T I T L E : AIR CONDITIONING - MODIFY UPPER/LOWER CABIN AIR OUTLET DUCTS

3 DATE : Jul 02/90 SERVICE BULLETIN No. : A320-21-1021

SERVICE BULLETIN No. A320-21-1021

Replacement of Ducts and Cabin Air Outlets Figure 1

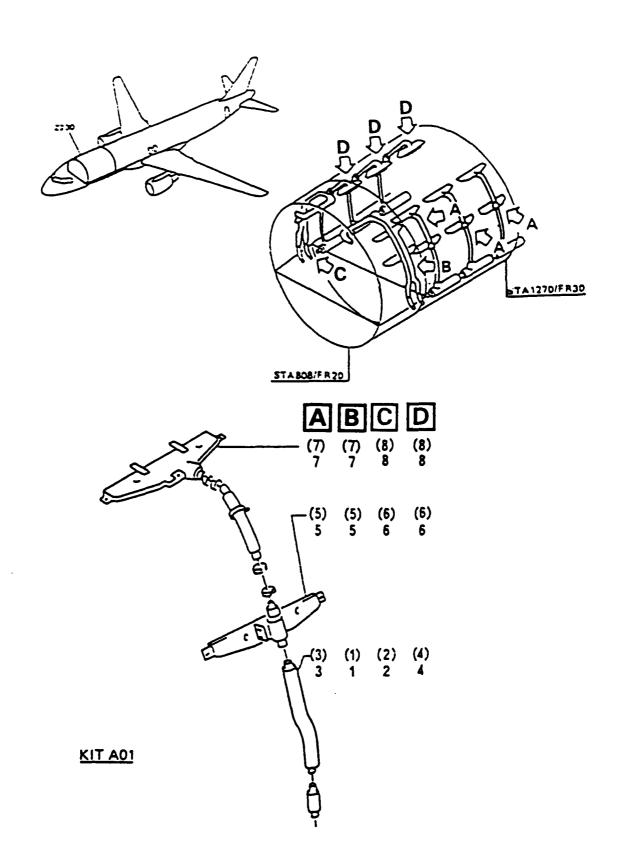
- Disconnect, remove and do not re-use the ducts (1), (2), (3) and (4), the lower air outlets (5) and (6) and the upper air outlets (7) and (8). Retain the connecting parts.
- 2 Install these new ducts, lower air outlets and upper air outlets with the retained connecting parts:

D2121113600000	item 1
D2121113600100	item 2
D2121113800000	item 3
D2121113800100	item 4
D2121114100000	item 5
D2121114100100	item 6
D2121114200000	item 7
D2121114200100	item 8

Replacement of Ducts and Cabin Air Outlets Figure 2

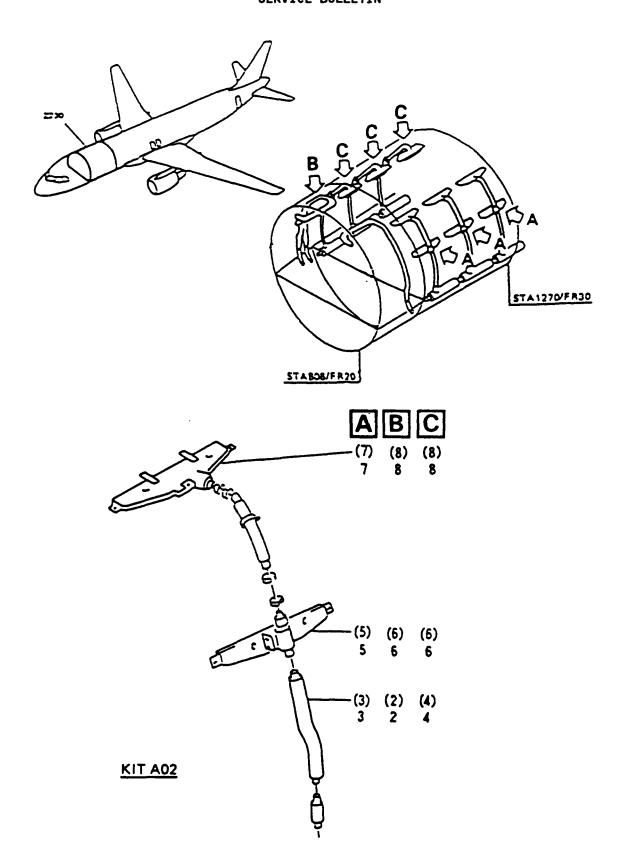
Disconnect, remove and do not re-use the ducts (2), (3) and (4), the lower air outlets (5) and (6) and the upper air outlets (7) and (8). Retain the connecting parts.

D2121113600100	item 2
D2121113800000	item 3
D2121113800100	item 4
D2121114100000	item 5
D2121114100100	item 6
D2121114200000	item 7
D2121114200100	item 8

Replacement of Ducts and Cabin Air Outlets Figure 3

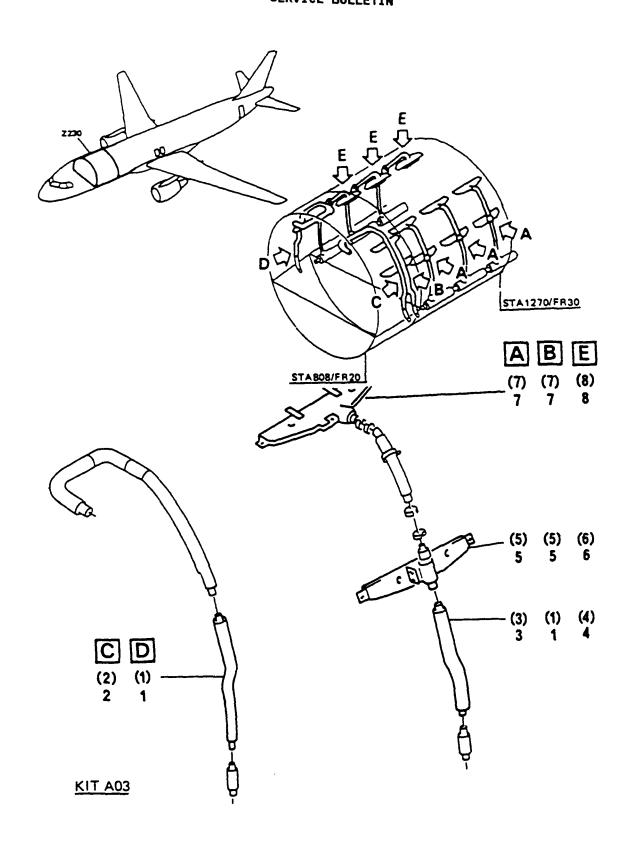
- Disconnect, remove and do not re-use the ducts (1), (3) and (4), the lower air outlets (5) and (6) and the upper air outlets (7) and (8). Retain the connecting parts.
- 2 Install these new ducts, lower air outlets and upper air outlets with the retained connecting parts:

item 1
item 3
item 4
item 5
item 6
item 7
item 8

Replacement of Ducts and Cabin Air Outlets Figure 4

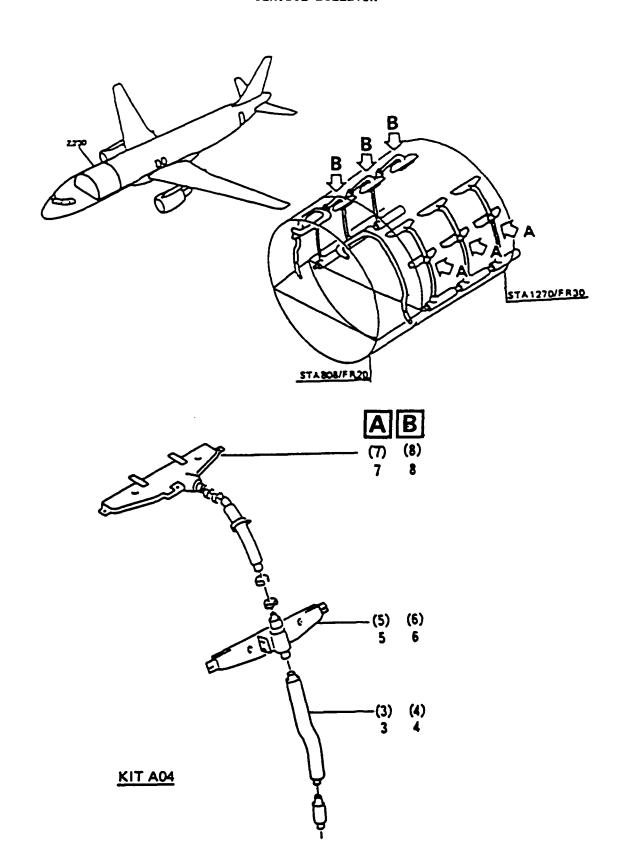
- Disconnect, remove and do not re-use the ducts (3) and (4), the lower air outlets (5) and (6) and the upper air outlets (7) and (8). Retain the connecting parts.
- Install these new ducts, lower air outlets and upper air outlets with the retained connecting parts:

D2121113800000	item 3
D2121113800100	item 4
D2121114100000	item 5
D2121114100100	item 6
D2121114200000	item 7
D2121114200100	item 8

Replacement of Ducts and Cabin Air Outlets Figure 5

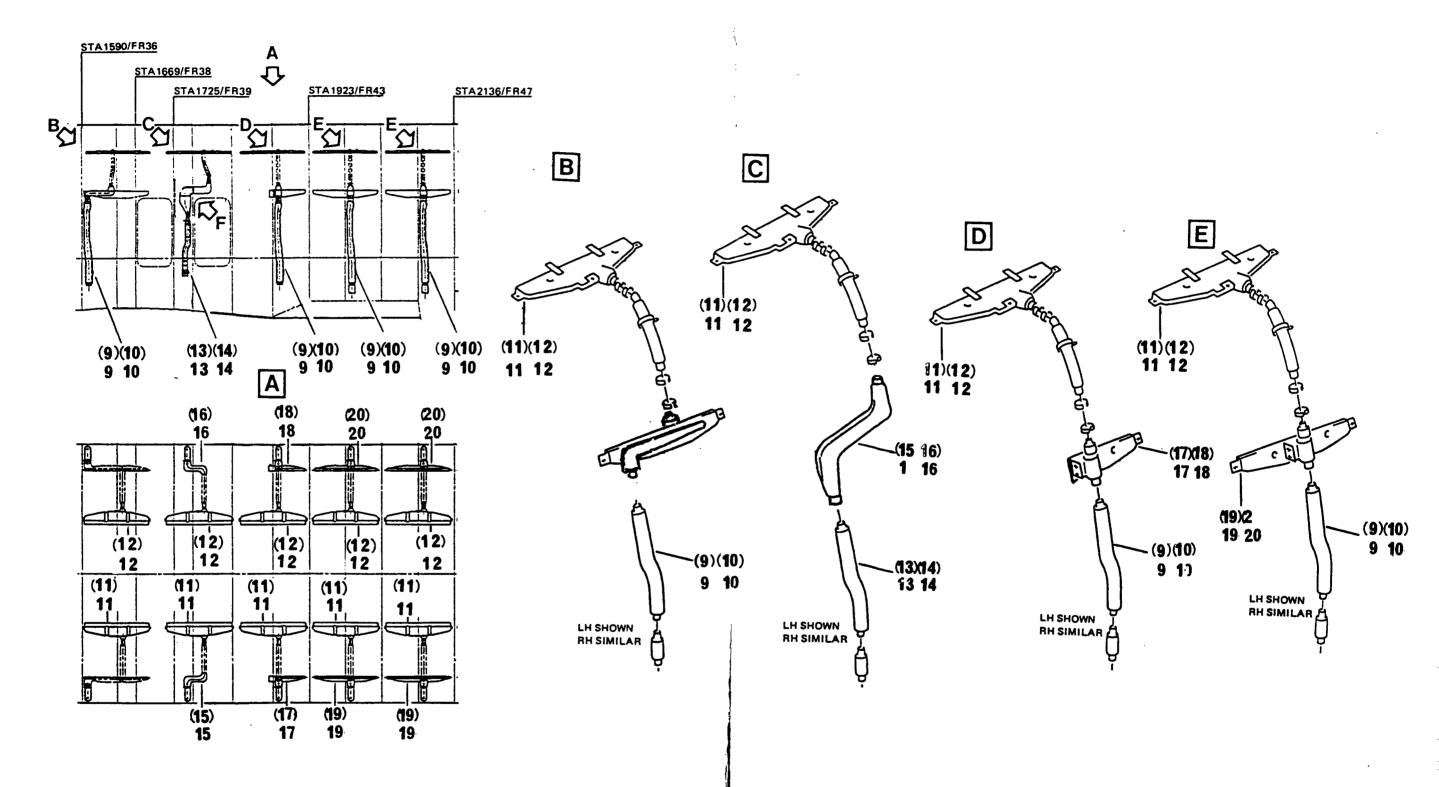
- Disconnect, remove and do not re-use the ducts (3) and (4), the lower air outlets (5) and (6) and the upper air outlets (7) and (8). Retain the connecting parts.
- 2 Install these new ducts, lower air outlets and upper air outlets with the retained connecting parts:

D2121113800000	item 3
D2121113800100	item 4
D2121114100000	item 5
D2121114100100	item 6
D2121114200000	item 7
D2121114200100	item 8

Replacement of Ducts and Cabin Air Outlets Figure 6

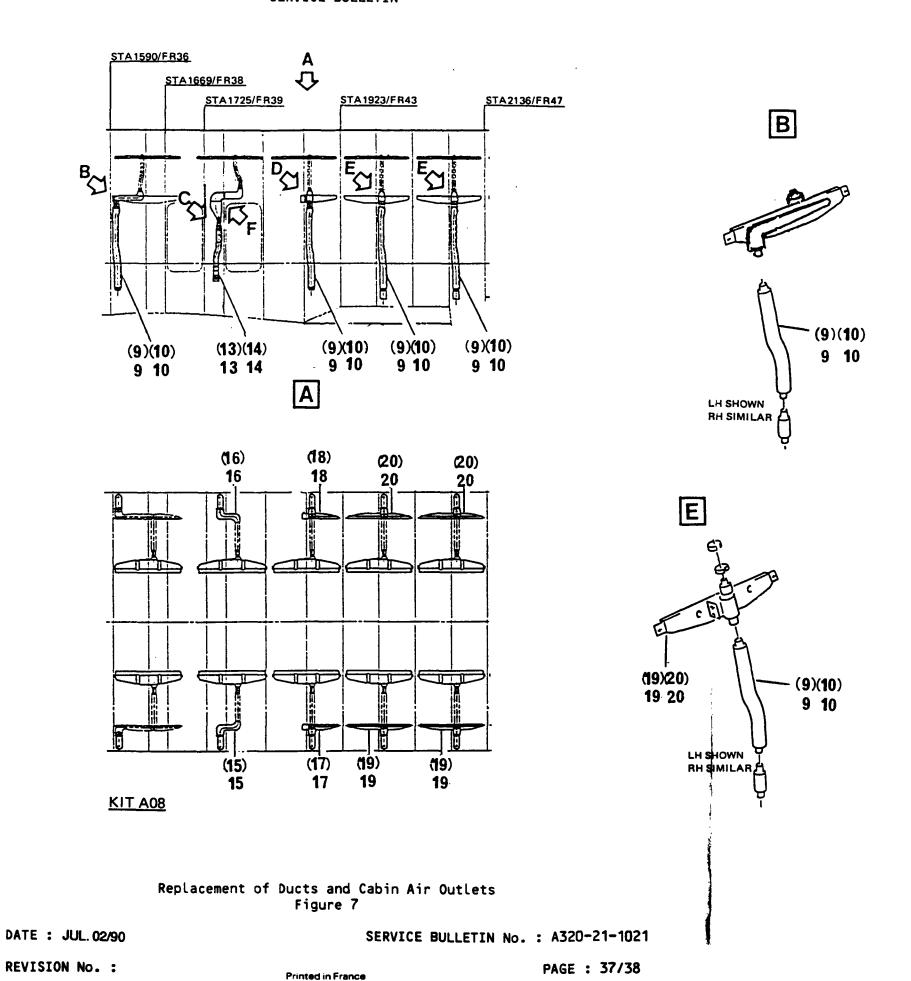
- Disconnect, remove and do not re-use the ducts (9), (10), (13) and (14), the lower air outlets (17), (18), (19) and (20) and the upper air outlets (11) and (12). Retain the connecting parts.
 - NOTE: If Service Bulletin A320-21-1020 is embodied, return the lower air outlet D2127107901000, item (17) and D2127107901100, item (18) to Airbus Industrie, Spares Support Center.
- Modify the adapter section between FR39 and FR41 as follows: Refer to Figure 8
 - Remove and do not re-use the screws (21), (24) and (26), the washers (22) and the spacers (23) and (25).
 - Remove and do not re-use the adapter (15) and (16).
 - On FR40 drill out the rivets and remove and do not re-use the bracket (27).
 - Seal the rivet holes with rivets NAS1097DD5-6 and NAS1097DD5-7.

D2127107900600	item 17
D2127107900700	item 18
D2127111900000	item 19
D2127111900100	item 20
D2127112100000	item 15
D2127112100100	item 16
D2127112500000	item 11
D2127112500100	item 12
D2127112700000	item 9
D2127112700100	item 10
D2127112900000	item 13
D2127112900100	item 14

Replacement of Ducts and Cabin Air Outlets Figure 9

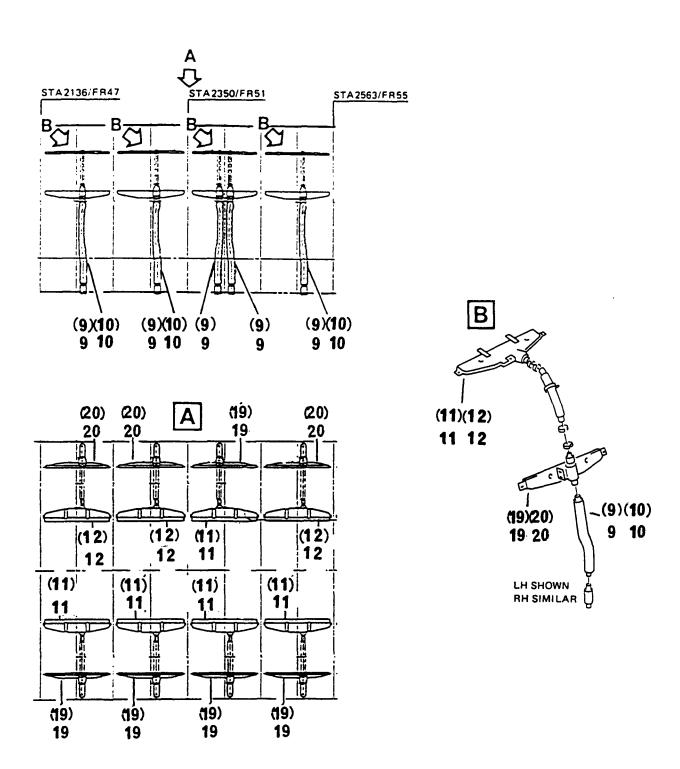
- Disconnect, remove and do not re-use the ducts (9) and (10), lower air outlets (19) and (20) and upper air outlets (11) and (12). Retain the connecting parts.
- Install these new ducts, lower air outlets and the upper air outlets with the retained connecting parts:

D2127111900000	item 19
D2127111900100	item 20
D2127112500000	item 11
D2127112500100	item 12
D2127112700000	item 9
D2127112700100	item 10

Replacement of Ducts and Cabin Air Outlets Figure 11

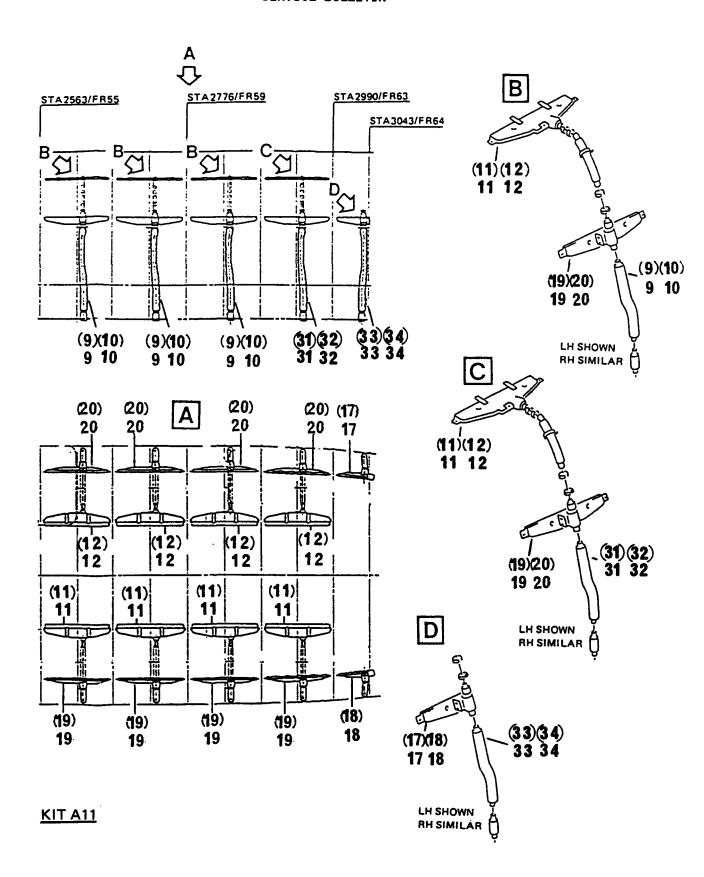
Disconnect, remove and do not re-use the ducts (9) and (10), (31), (32), (33) and (34), the lower air outlets (17), (18), (19) and (20) and the upper air outlets (11) and (12). Retain the connecting parts.

Replacement of Ducts and Cabin Air Outlets Figure 12

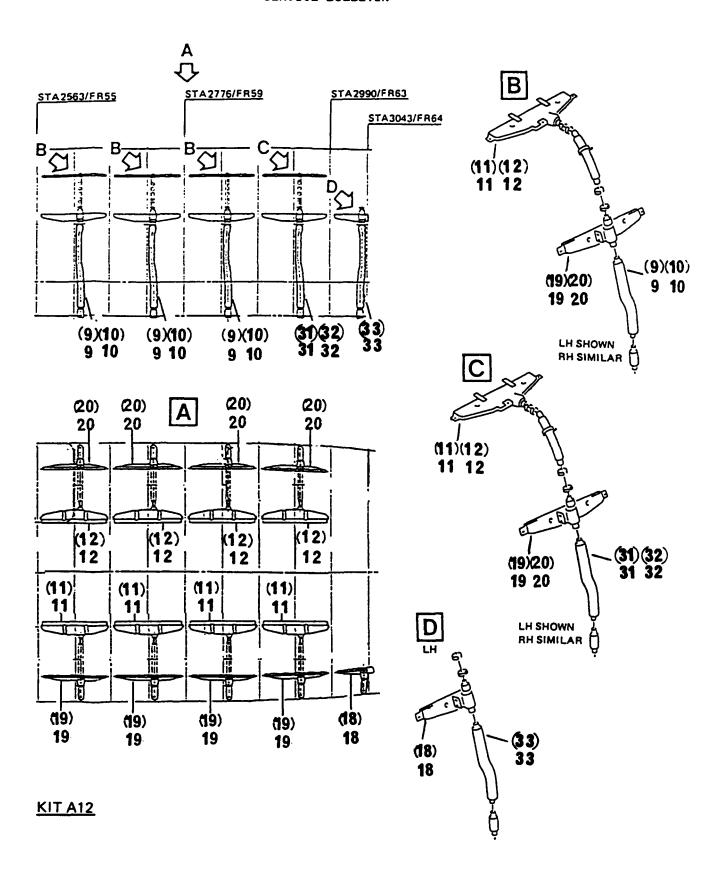
Disconnect, remove and do not re-use the ducts (9), (10), (31), (32) and (33), the lower air outlets (18), (19) and (20) and the upper air outlets (11) and (12). Retain the connecting parts.

Replacement of Ducts and Cabin Air Outlets Figure 13

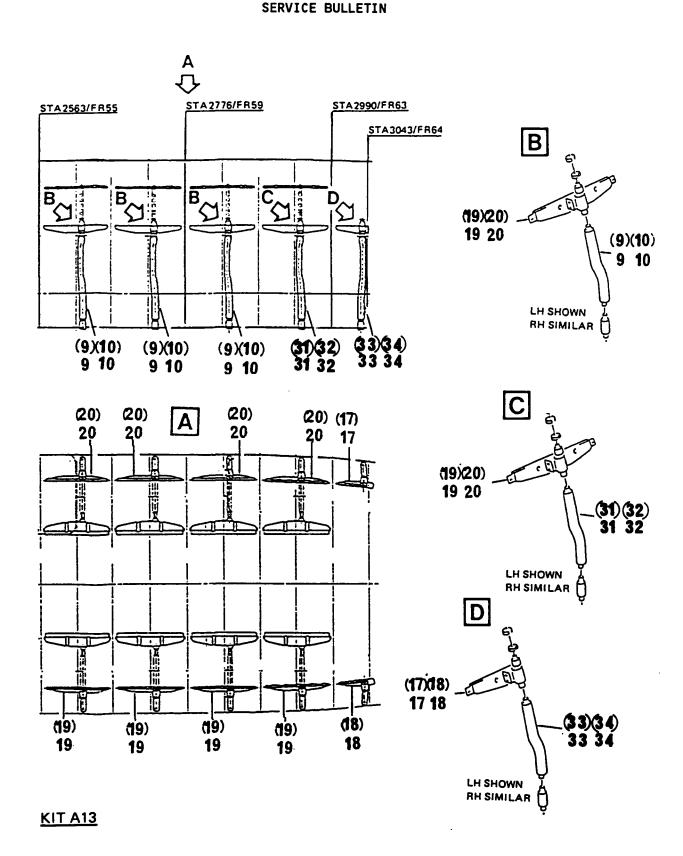
Disconnect, remove and do not re-use the ducts (9), (10), (31), (32), (33) and (34) and the lower air outlets (17), (18), (19) and (20). Retain the connecting parts.

Replacement of Ducts and Cabin Air Outlets Figure 14

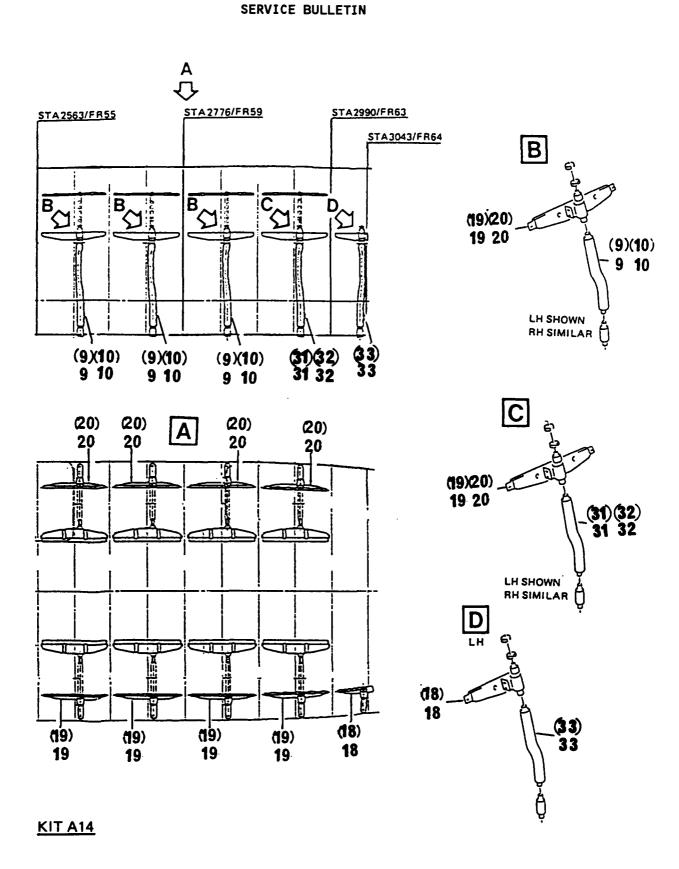
Disconnect, remove and do not re-use the ducts (9), (10), (31), (32), (33) and the lower air outlets (18), (19) and (20). Retain the connecting parts.

Replacement of Ducts and Cabin Air Outlets Figure 15

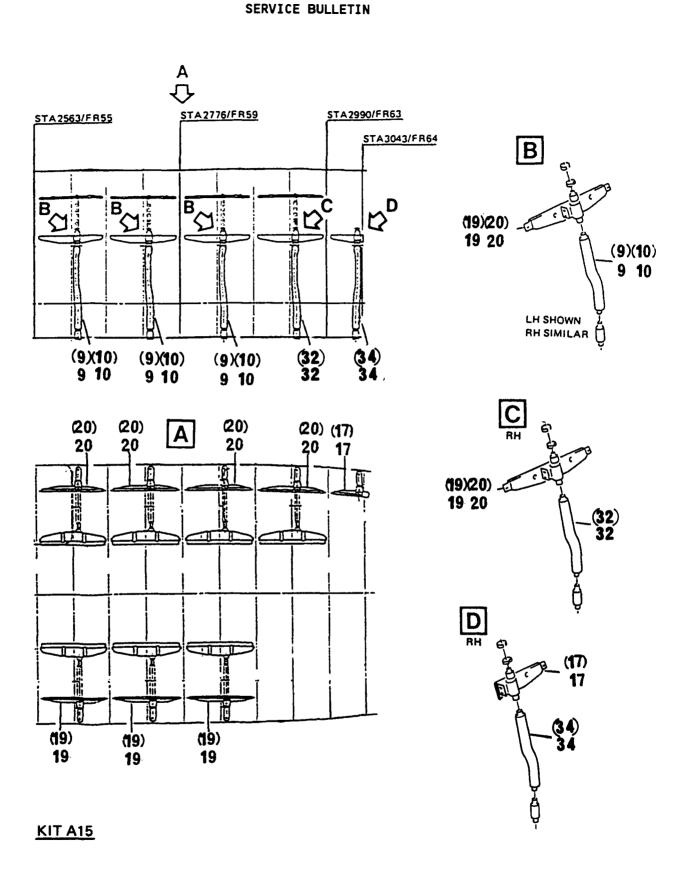
Disconnect, remove and do not re-use the ducts (9), (10), (32) and (34) and the lower air outlets (17), (19) and (20). Retain the connecting parts.
